Section 42A Report

Proposed Plan Change 1 — Regional Coastal Plan — Kermadec and Subantarctic Islands

Report prepared by: Jesse Gooding

15 May 2026

Figure 1 – RCP Map 1 Excerpt showing Musgrave Inlet, Lake Hinemoa and the 300m, 600m and 1000m from MWHS zones.

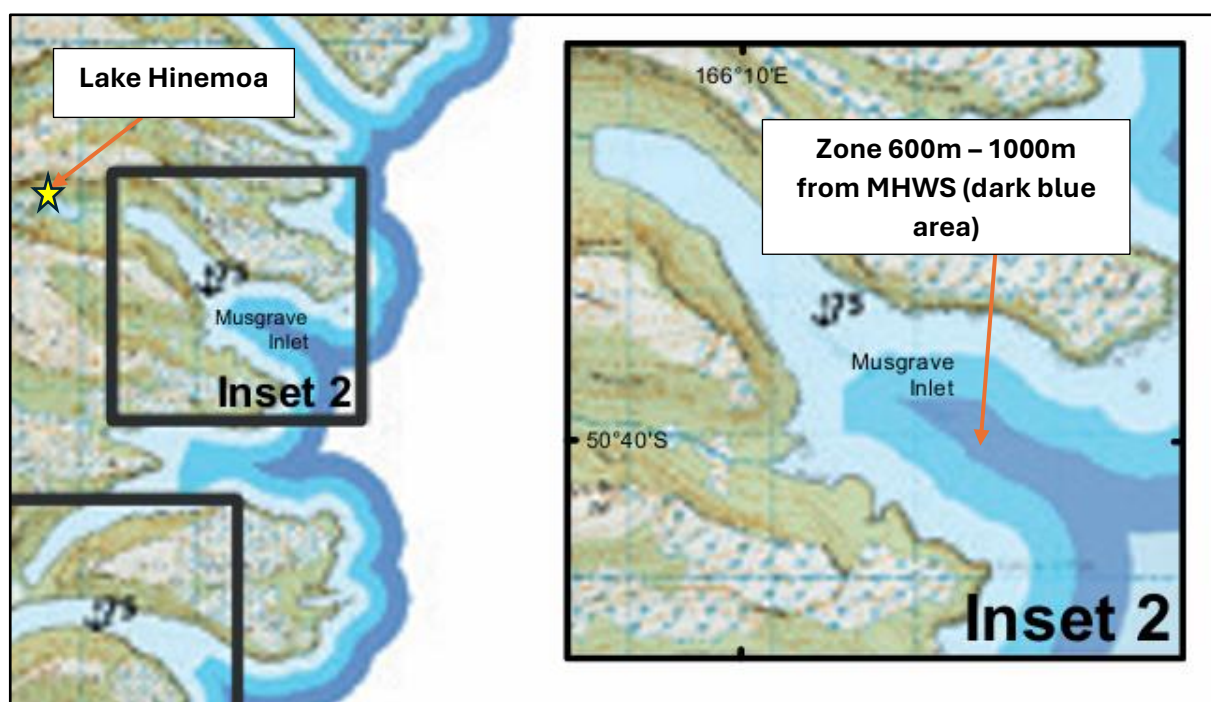
62. Mr Russ also points to several landing sites at Auckland and Campbell Islands where he considers access will be unnecessarily restricted by the proposed changes. As outlined in Appendix D, Mr Dilley has considered this issue and confirms that further amendments to proposed Rule 40(C) to enable operators to access certain locations would be appropriate without compromising policy intent of the proposed Rule, which is to provide for the safe use of ancillary craft within appropriate permitted thresholds.

71. My recommended drafting changes to proposed Rule 40, in response to submissions and the navigation safety advice of Mr Dilley are:

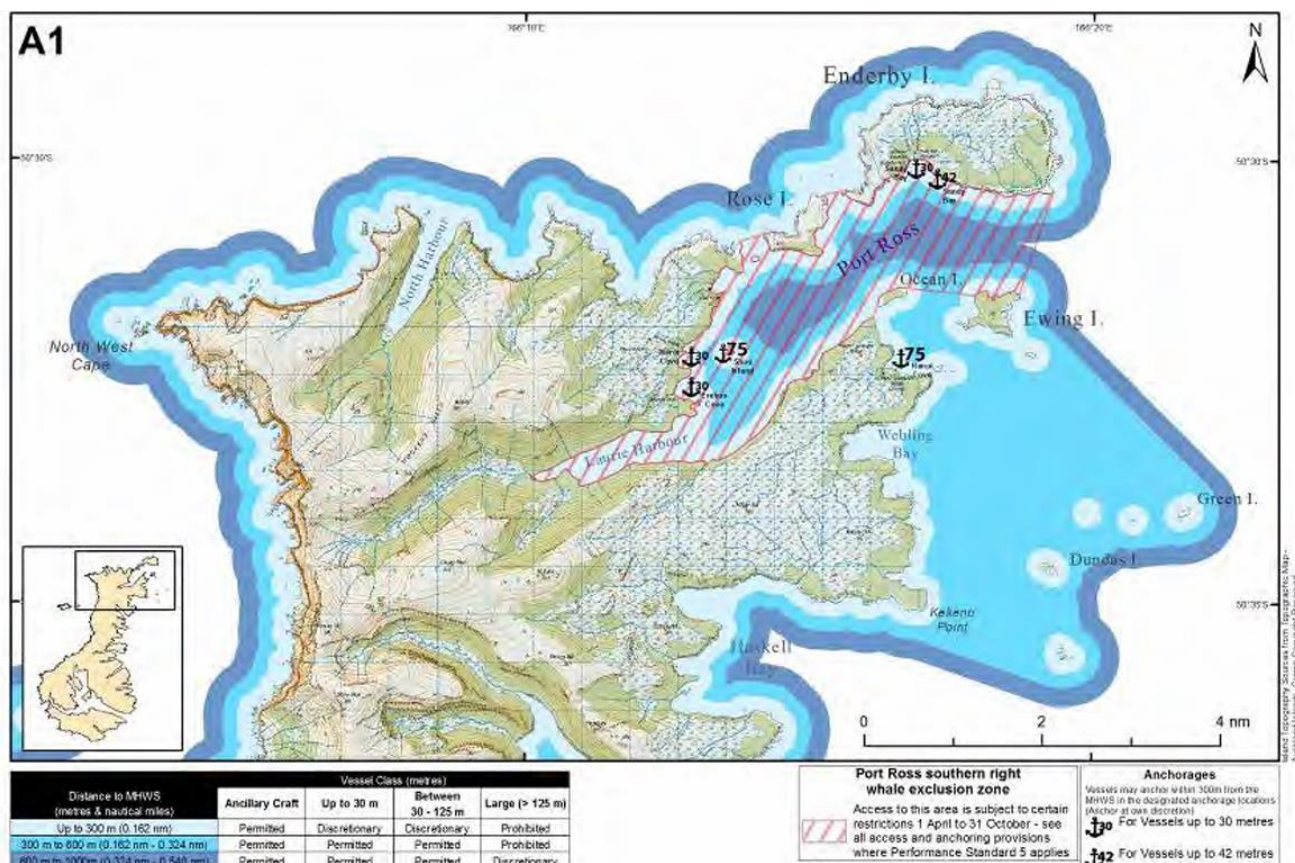
- a. limiting the categories of vessels that can enter Port Ross (more specifically, the red hashed area shown on Figure 2 below) over the winter months as a permitted activity to vessels undertaking DOC management or research activities (as provided for in Rules 38 and 39), and

Figure 3. Location of requested anchorage at Tucker Point as requested by the submitters, Port Ross.

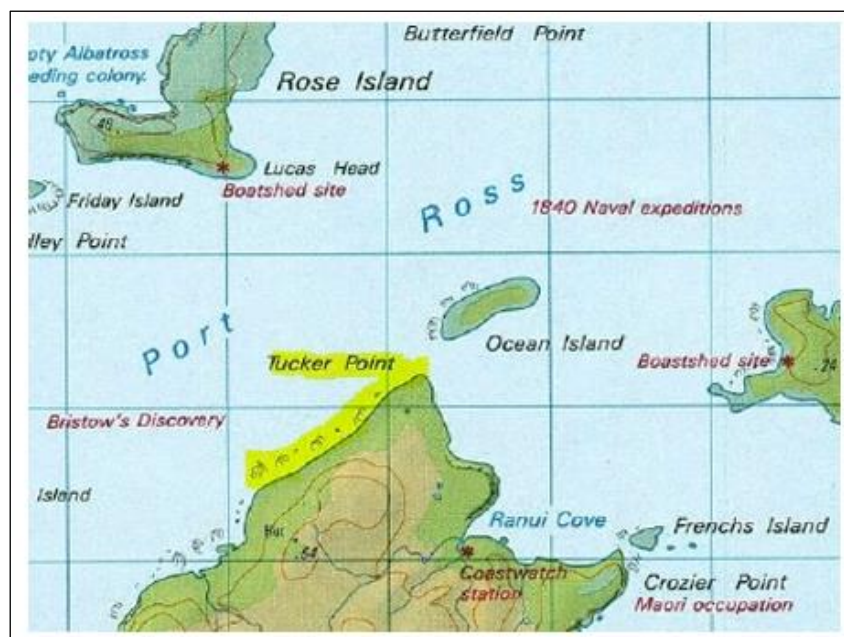
178. The proposed changes have attracted submissions from fishing and seafood industry representatives and the NZSLT. Fishing and seafood submitters support the addition of the two anchorages but seek additional locations be provided. In particular, they seek a permitted anchorage at Tucker Point²⁷, in Port Ross, as shown below:

179. Sanford (submission point 5.6) welcome the addition of new anchorages at Round Bay and Crab Point but seek consideration of Lookout Point²⁸ as a permitted anchorage location.

Figure 5. Figure of Eight Island 300m from MHWS Permitted Activity Exclusion Area

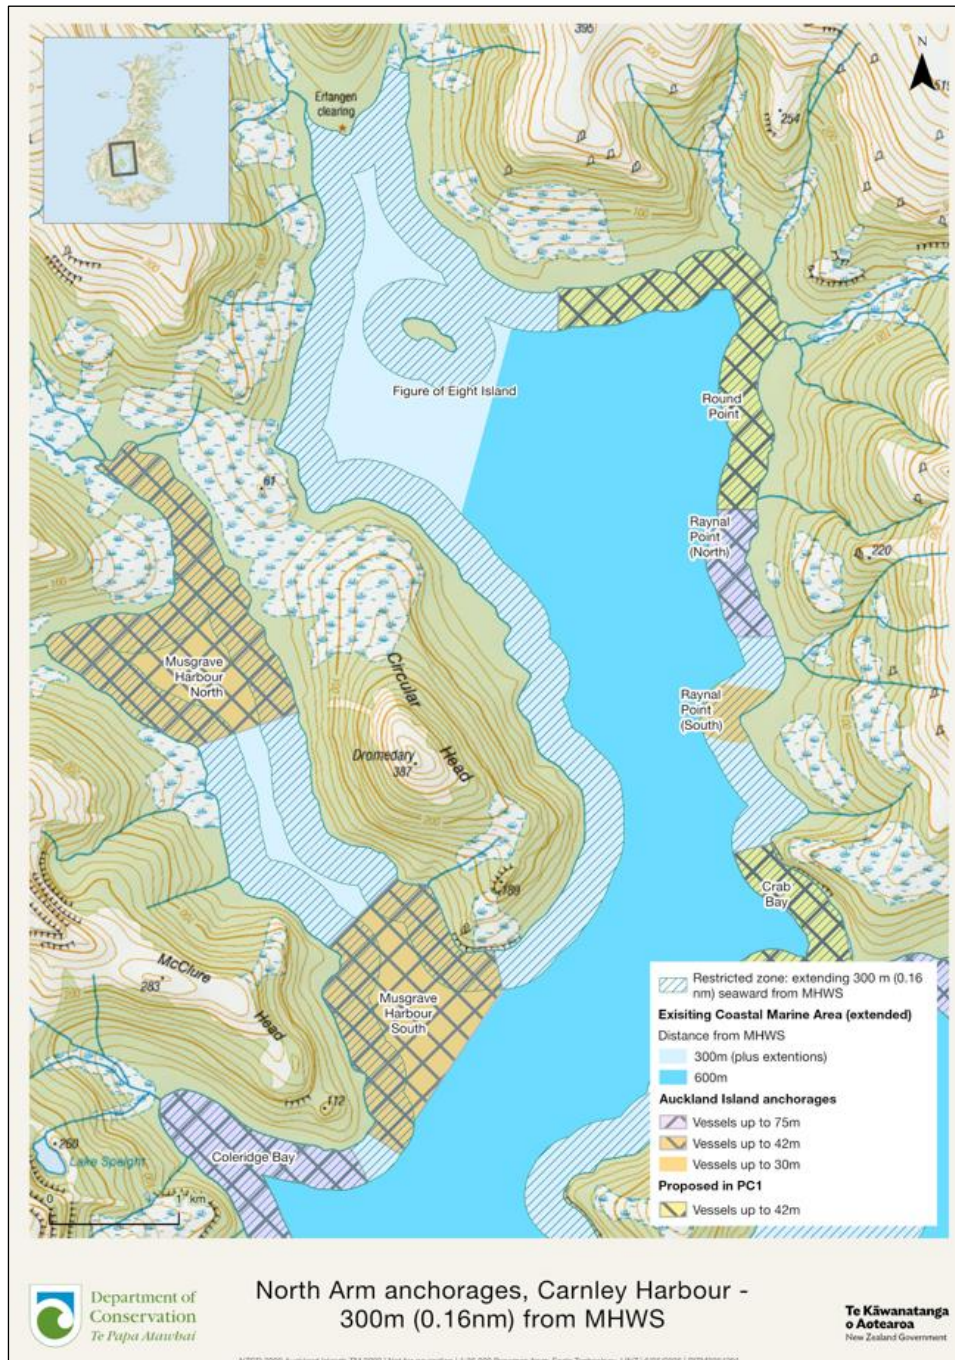
201. Excluding anchoring in proximity to Figure of Eight Island is an understandable request given the Island is home to an important New Zealand sealion colony (see the advice of Kat Manno Appendix F). The submitter has not stated how far from the Island an anchorage exclusion should apply but I note that under the Operative Plan anchoring is not permitted within 0.16nm (300m) of Figure of Eight Island’s MHWS. Nothing proposed in PC1 seeks to change this status quo restriction on anchoring within 300m of the Figure of Eight Island MHWS. The closest permitted anchorage within 300m of MWHS, “in proximity” to Figure of Eight Island is the proposed Round Point Anchorage. For completeness, I confirm this does not encroach into the Figure of Eight Island 300m zone.

202. The 300m zone as it applies around the Island is not shown on any of the Operative Plan maps or chartlets. For the benefit of submitters and the Hearings commissioners I have included it below. Vessels cannot access and anchor in the blue hashed areas around Figure of Eight Island as a permitted activity. That clarification aside I recommend the NZSLT relief on the Rule be **declined**.
